FINAL SAFETY EVALUATION BY THE OFFICE OF NUCLEAR REACTOR REGULATION

TOPICAL REPORT ANP-10297P, REVISION 0

“THE ARCADIA® REACTOR ANALYSIS SYSTEM FOR PWRs

AREVA NP, INC.

Figure 1: Representative Axial Power Shape with Grid Depressions

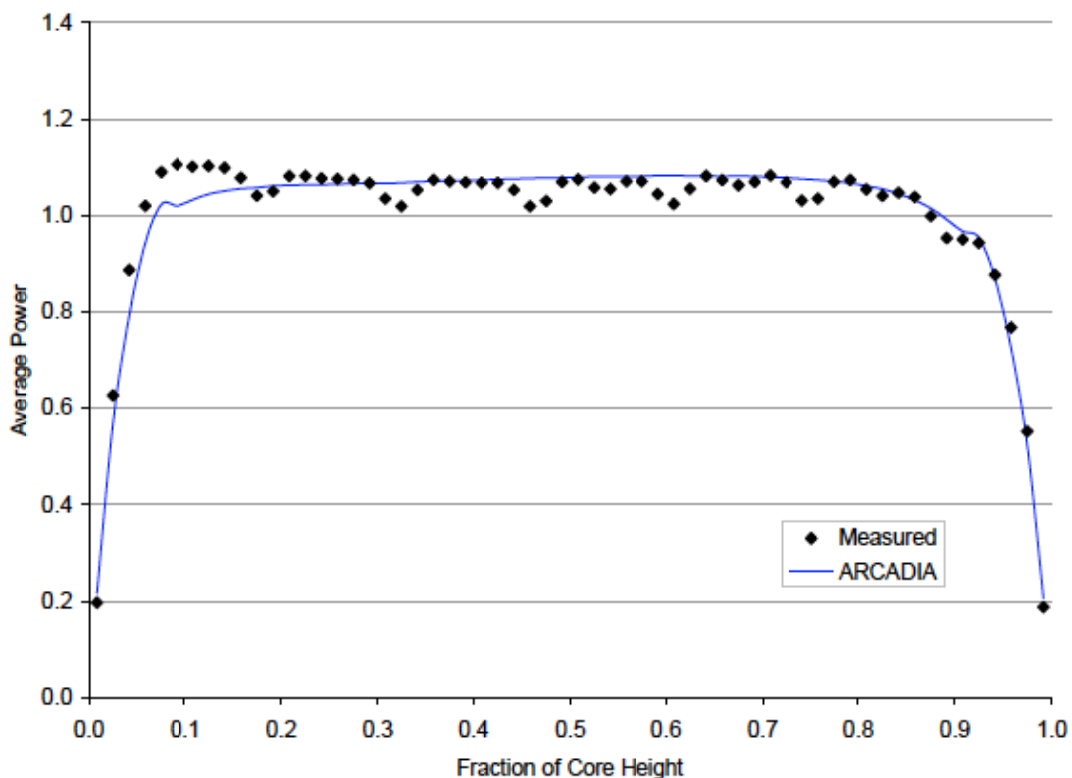
As expected the measured average axial power shapes have the similar axial power shape in all plants. A representative profile is shown in Figure 1. The grid spacer effects (grid depressions) seen on Figure 1, is common in axial power profiles of all plants except plant C and plant T. The plants C and T exhibit axial power shapes similar to the profile depicted in Figure 2. The smooth axial shape suggests that the power profile plots are not obtained from the actual detector readings but from reconstructed power shapes detector readings. However, the TR does not provide any information regarding the detector type or the power reconstruction method used in plant benchmarks. Consequently, AREVA was asked to provide further details for plant data and the interpolation/extrapolation method used to reconstruct the axial power shape if fixed core detectors were used in any plants.

AREVA provided (Reference 2) a table showing the detector type used in each plant in response to the RAI. As predicted, fixed incore Rhodium detectors are used in plants C and T. After detector power coefficients are calculated, detector inferred powers are linearly interpolated for each 24 axial node for comparison with the ARTEMIS™ predicted power. Based on the ARCADIA® benchmark results, this simple approach produces satisfactory results.
